Access Compliance Report Public Rights-of-Way (Curb Ramps)

Main Street: LAURINDA_WAY Cross Street: SANTA_CLARA_AVE Location: SW

ADA ID: RPAT211019085824 Ramp Type: Type 1 - Perpendicular Diagonal Initial Pass/Fail: Fail Overall Compliance: No Severity Score: 4

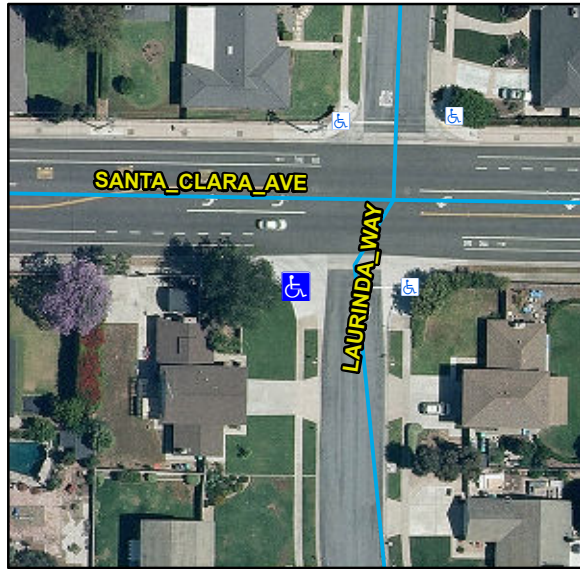
Compliance	Description	Data	Compliance	Description	Data
N/A	Ramp Length (in)	103	N/A	Flare Type LT	
No	Ramp Width (in)	47			N/A
Yes	Ramp Run Slope (%)	5.8	N/A	Flare Slope LT (%)	N/A
Yes	Ramp Cross Slope (%)	0.4	N/A	Flare Traversable LT	N/A
N/A	Landing Present	N/A	N/A	Flare Type RT	
N/A	Landing Length (in)	N/A			N/A
N/A	Landing Width (in)	N/A	N/A	Flare Slope RT (%)	N/A
N/A	Landing Run Slope (%)	N/A	N/A	Flare Traversable RT	N/A
N/A	Landing Cross Slope (%)	N/A	N/A	DWS Provided	N/A
N/A	Landing Movement Obstructed?	N/A	N/A	DWS Contrast	N/A
	Landing Movement Type	N/A	N/A	DWS Length (in)	N/A
N/A	Landing Shared	N/A	N/A	DWS Full Width	N/A
N/A	Clear Space	Yes	N/A	DWS Offset Left (in)	N/A
N/A	Clear Space To Crosswalk (in)	N/A	N/A	DWS Offset Right (in)	N/A
N/A	Marked Crosswalk 1	No	N/A	Marked Crosswalk 2	No
	Crossing 1 Direction	E		Crossing 2 Direction	N
	Marked Crosswalk 1 Width (in)	N/A		Marked Crosswalk 2 Width (in)	N/A

N/A	Ramp Inside Crosswalk 1	N/A	Yes	Ramp Inside Crosswalk 2	N/A
	Crossing 1 Slope (%)	1.9		Crossing 2 Slope (%)	7.7
	Crossing 1 Cross Slope (%)	1.1		Crossing 2 Cross Slope (%)	1.3
N/A	Gutter Ponding	N/A	No	Curb Slope	10.5
Yes	Gutter Lip Height (in)	0		Road Run Slope (%)	0.4
N/A	Gutter Run Slope (%)	N/A		Road Cross Slope (%)	1.9
N/A	Gutter Cross Slope (%)	N/A			
Yes	Overall Surface Condition: Acceptable		Yes	Perp Joint Present	Yes
	Cross Gutter Present?	Yes		Spandrel Present?	Yes
	Replace Cross Gutter?	No		Replace Spandrel?	No

Remove & Replace Curb Ramp With Two New Directional Ramps or Equivalent.

R304.2.2, R304.5.1, STD 1115
